101400-001-1:Shop Drawings

Status	Open Submitted
Spec section	101400 EXTERIOR SIGNAGE
Manager	Ryan Schelin (Je Dunn Construction Company (013735))
Responsible contractor	Ryan Schelin (Je Dunn Construction Company (013735))
Reviewers step 01	Ryan Schelin (Je Dunn Construction Company (013735))

Job: [LSMC ED Expansion](#)

EXTERIOR SIGNAGE
 #8633 - HCA EXTERIOR CANOPY

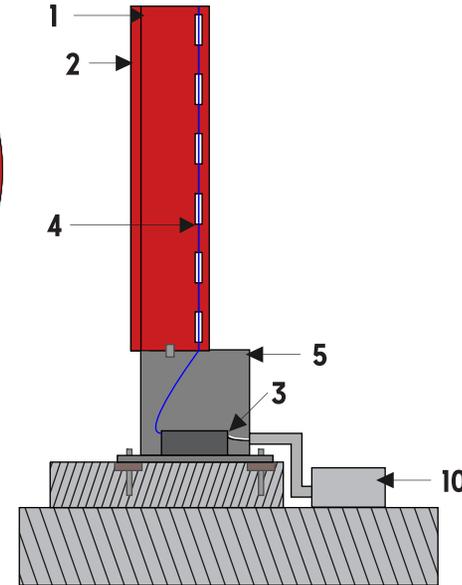
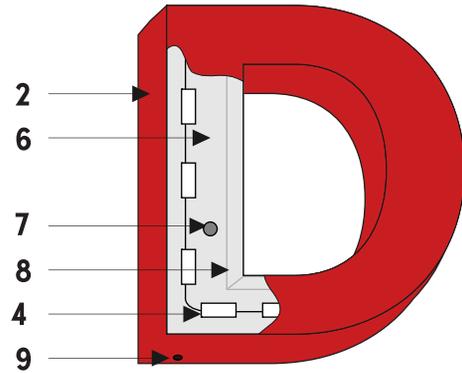
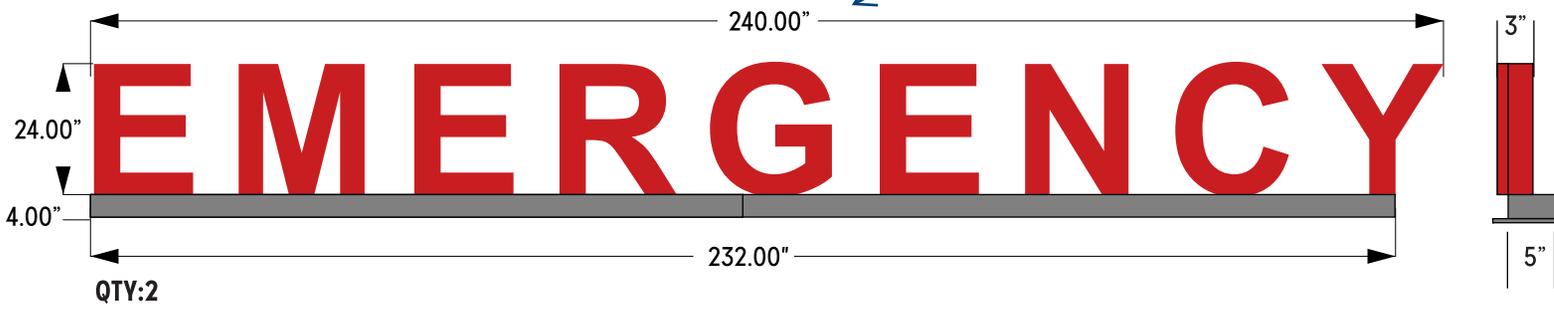
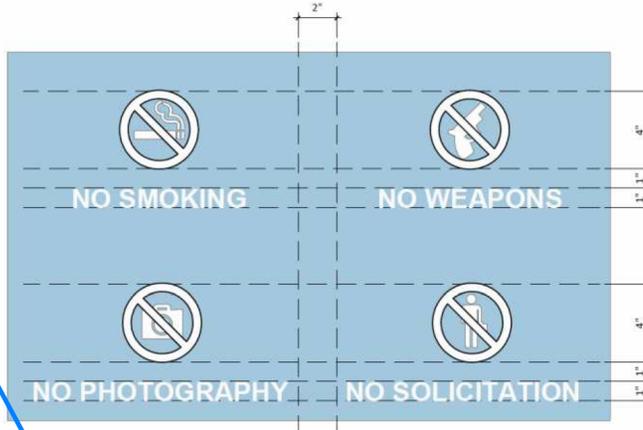
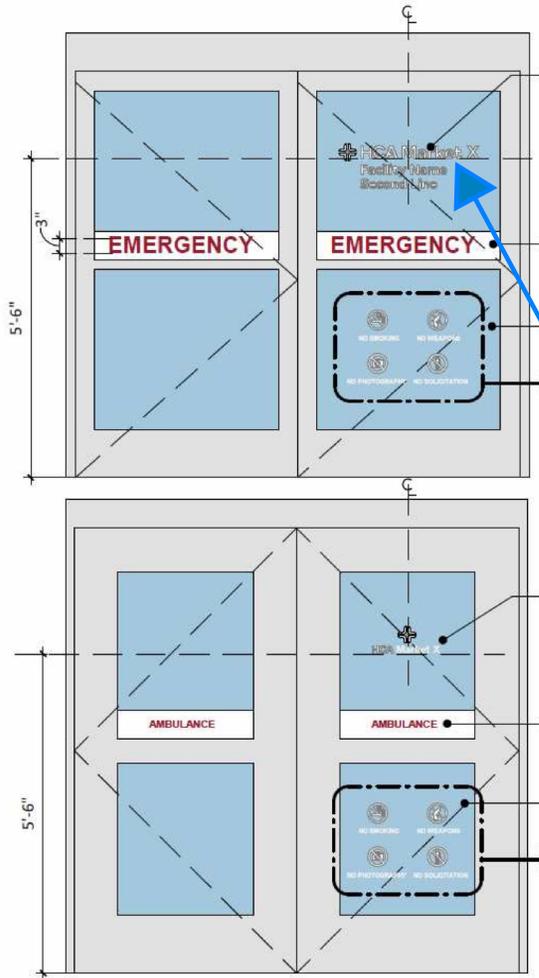
Provide as part of deferred submittal.

Resubmit for record only.

Reference RFI-098 - RS JE Dunn
